SUBJECT: Forwards response to 840814 request for review of proof & review Tech Specs. Function of committee for review & comment on Rev 3 to NUREG-0212 provided. Implementation of encl changes necessary for certification of Tech Specs.

September 14, 1984
ANPP-30516

Subject: PVNGS Units 1, 2, and 3
Proof and Review Technical Specifications
Docket Nos. STN 50-528/529/530
File: 005-419.05

FIGURE 3.1-3

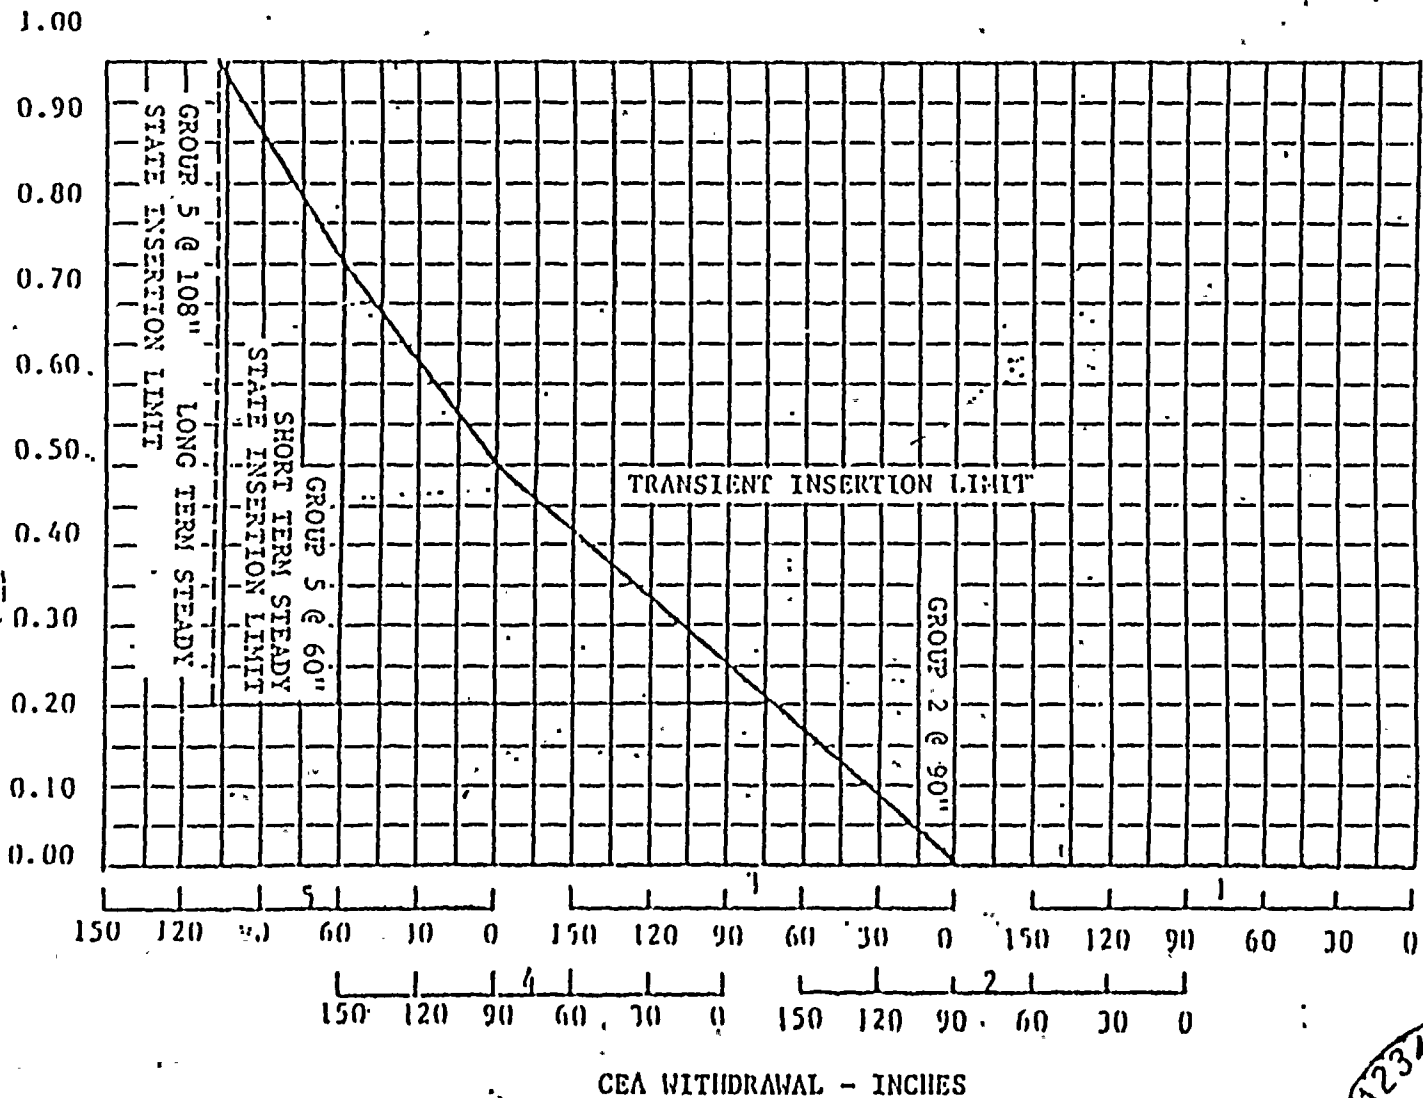
##Following a reactor power cutback in which (1) Regulating Groups ~~4 and/or 5~~ OR REG. are dropped or (2) Regulating Groups ~~4 and/or 5~~ are dropped and the remaining GROUPS AND S Regulating Groups (Groups 1, 2, 3, and 4) sequentially inserted, the Transient Insertion Limit of Figure 3.1-3 can be exceeded for up to 2 hours.

FIGURE B 3/4.4-1

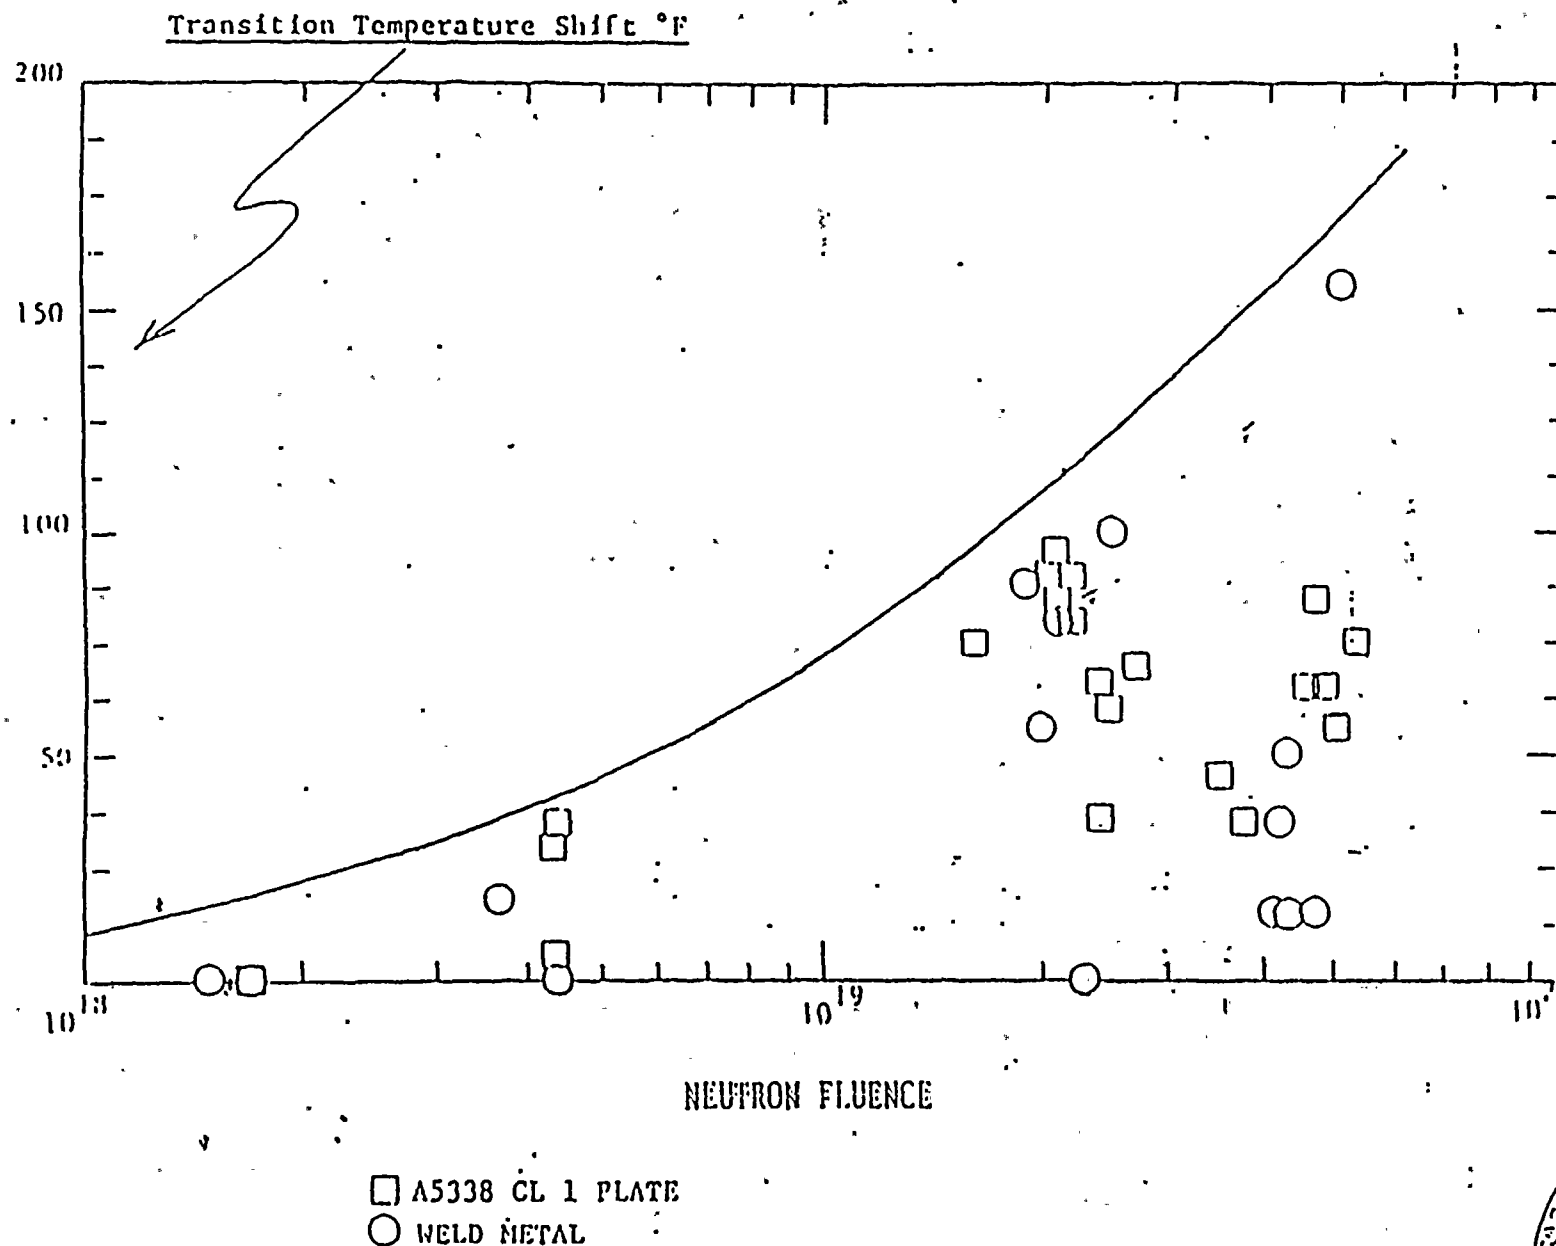
Figure 3/4 3.3-1 should be modified to add a curve of Pressure/Temperature limits for RCS cooldown at a rate of 40°F/hour which is used as the basis of the LCO in Section 3.4.8.1

FIGURE 6.2-1
OFFSITE ORGANIZATION

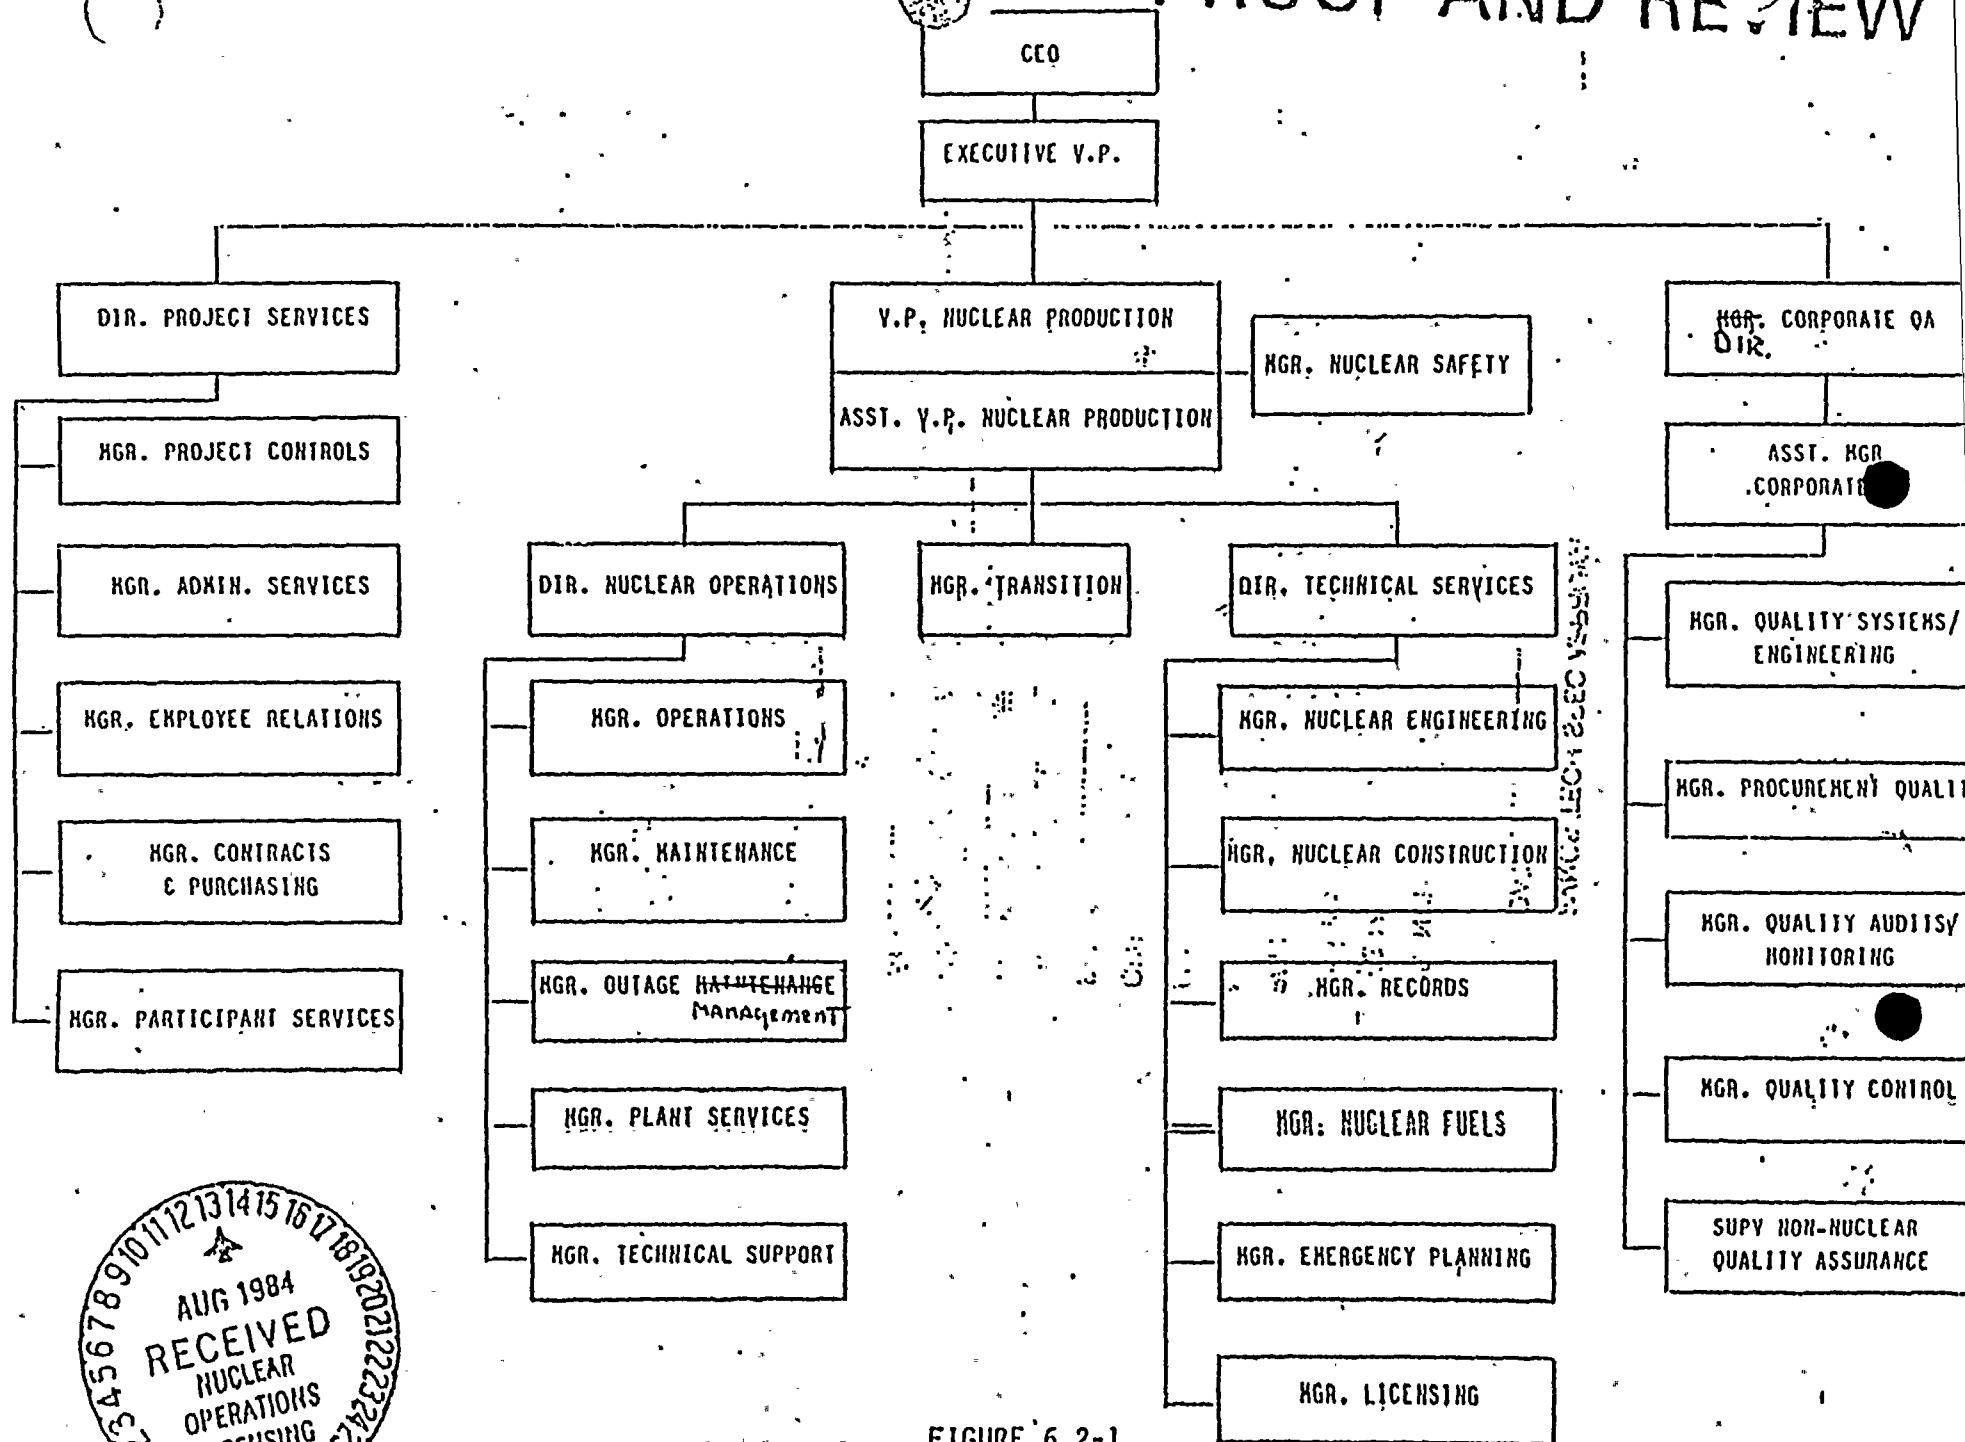
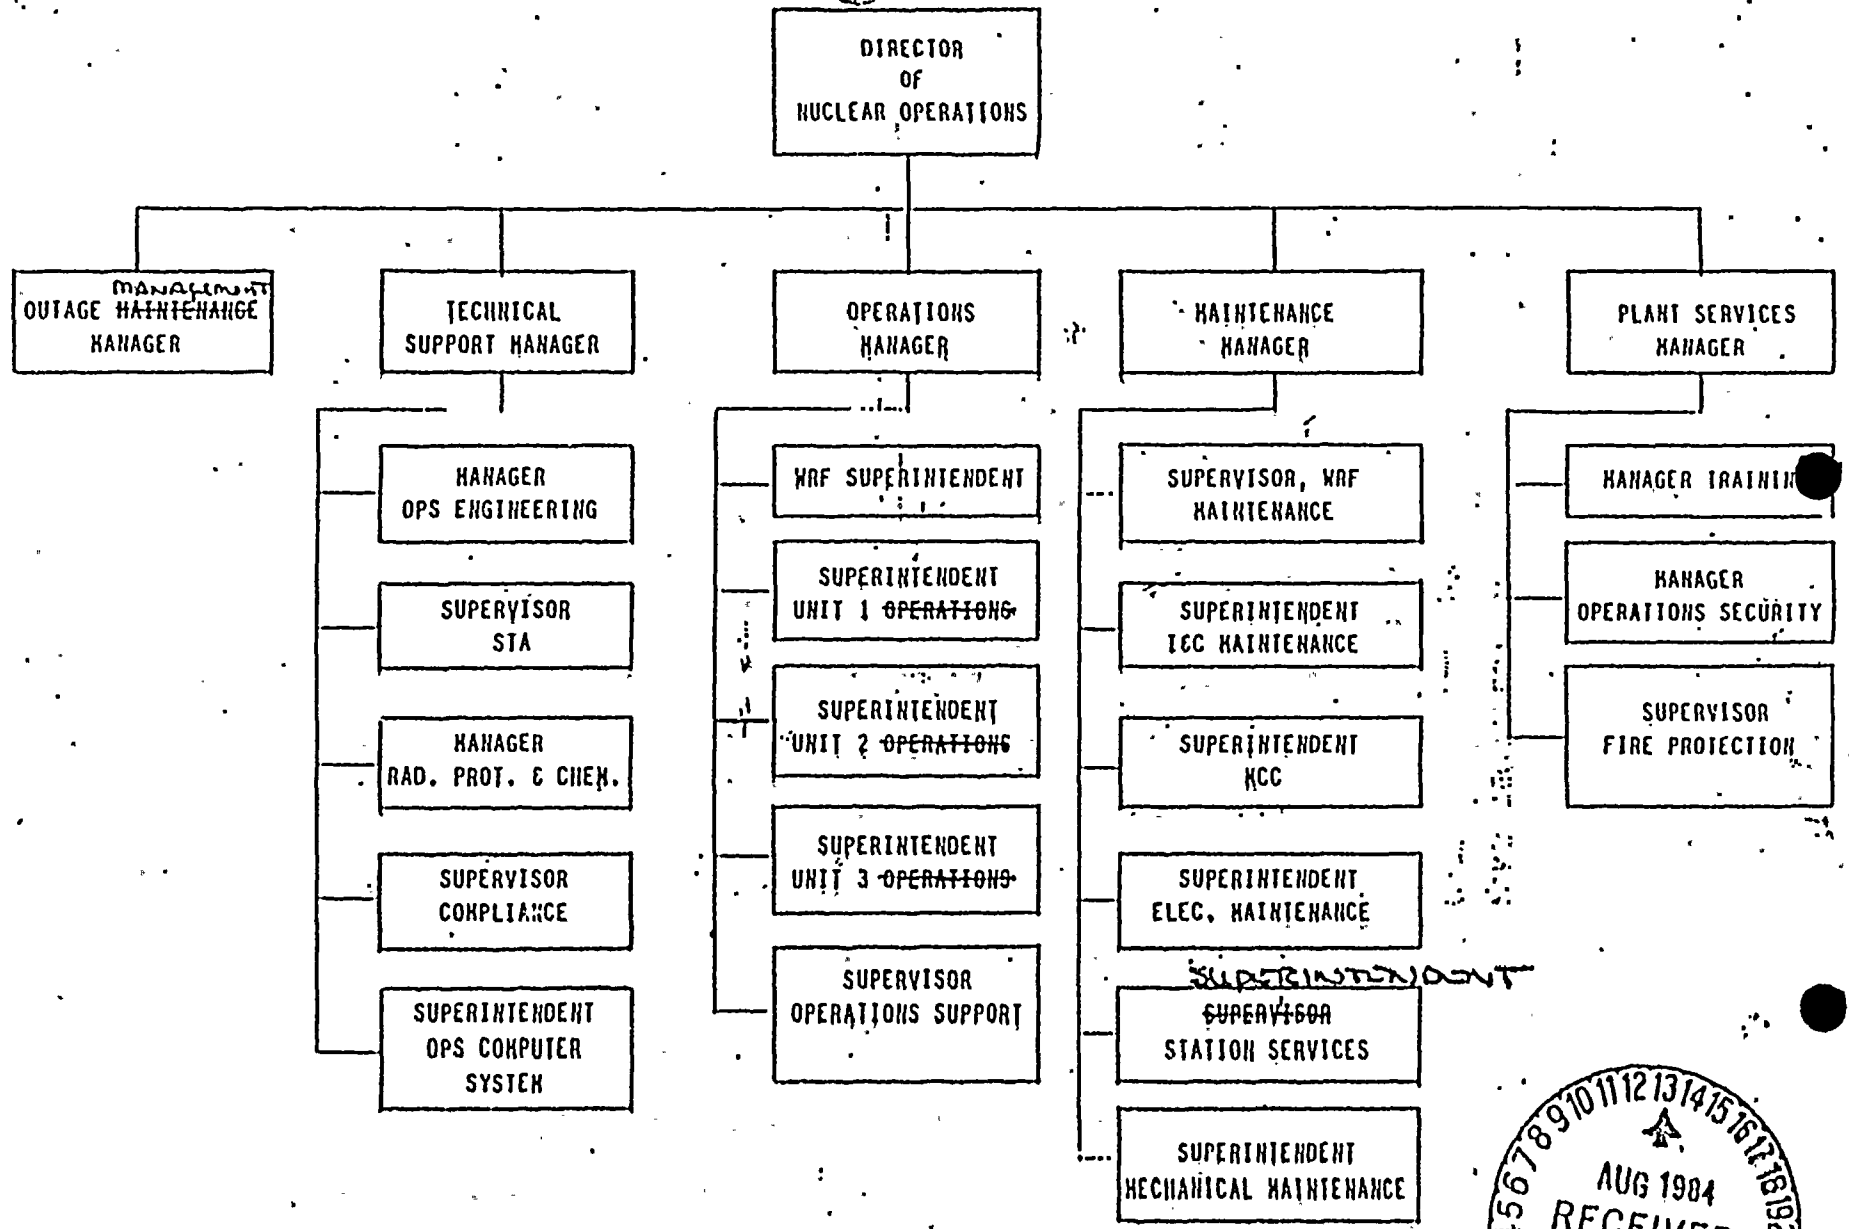
6.2.1 The offsite organization for unit management and technical support shall be as shown in Figure 6.2-1. OR AS SPECIFIED IN THE FAR.

6.2.2.1 The unit organization shall be as shown in Figure 6.2-2 and: OR AS SPECIFIED IN THE FAR
